Product Change Notice (PCN)

PCN Number: PCN-0374166R-01

Product(s) Affected: CEP-2242

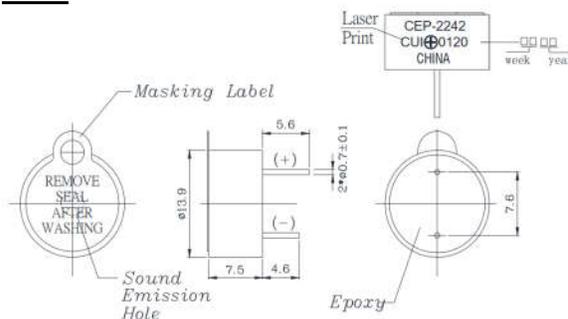
Description of Change: Form has been updated. Pin lengths have increased by .1mm and the diameter has increased .2mm. The height has decreased by .1mm. The sound hole masking label has been updated to cover the top of the buzzer. Function has increased to produce a min sound pressure level of 77dB and maximum current consumption has increased to 15mA. Operating voltage has also been updated to 4~16 VDC.
